CERTIFICATE OF APPROPRIATENESS

Property: 424 Euclid Street, Lot 6, Block 12, Woodland Heights Subdivision. The property includes a historic 1,623 square foot, one-story wood frame single-family residence, detached rear shed, and a detached rear garage situated on a 5,000 square foot (50' x 100') interior lot.

Proposal: Alteration – Addition

Recommendation: Denial - does not satisfy criteria

NORTH ELEVATION – FRONT FACING EUCLID STREET

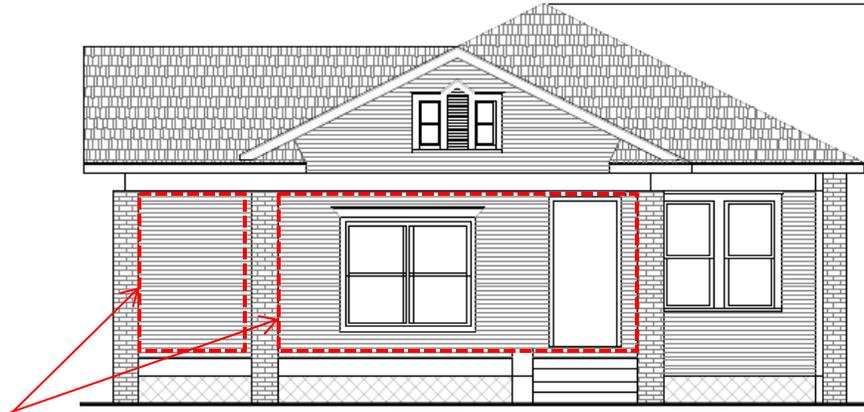
<i>The proposed addition is significantly taller and wider than the existing structure. The addition also encroaches on the existing structure, starting 20' from the front wall of the 38' deep existing structure. The large massing of the structure, its proximity to the front of the residence, and its encroachment over a large portion of the existing structure undermines the historical character of the property.</i> | |

<i>The existing residence's modest stature and massing are distinguishing qualities of this structure and other Contributing structures within the Woodland Heights Historic District. The proposed addition undermines these distinguishing qualities by resulting in a form that is much larger and complex.</i> | |

<i>The proposed large massing of the addition will undermine the character of the smaller existing structure because it is not compatible size and scale. The encroachment of the addition will destroy significant architectural material of the existing residence.</i> | |

EAST SIDE ELEVATION

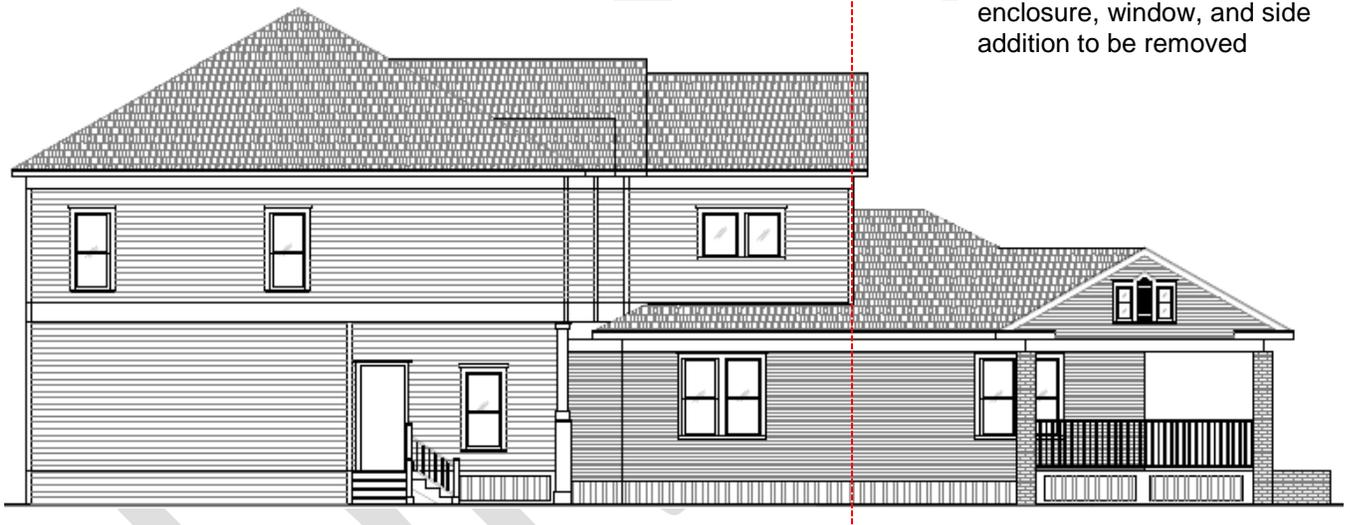
<i>The proposed encroachment over the rear 18' of the existing structure will impair the essential form and integrity of the structure. The existing one-story balloon frame walls underneath the encroaching addition will have to be heavily altered or replaced in order to carry the load of the added level.</i> | |
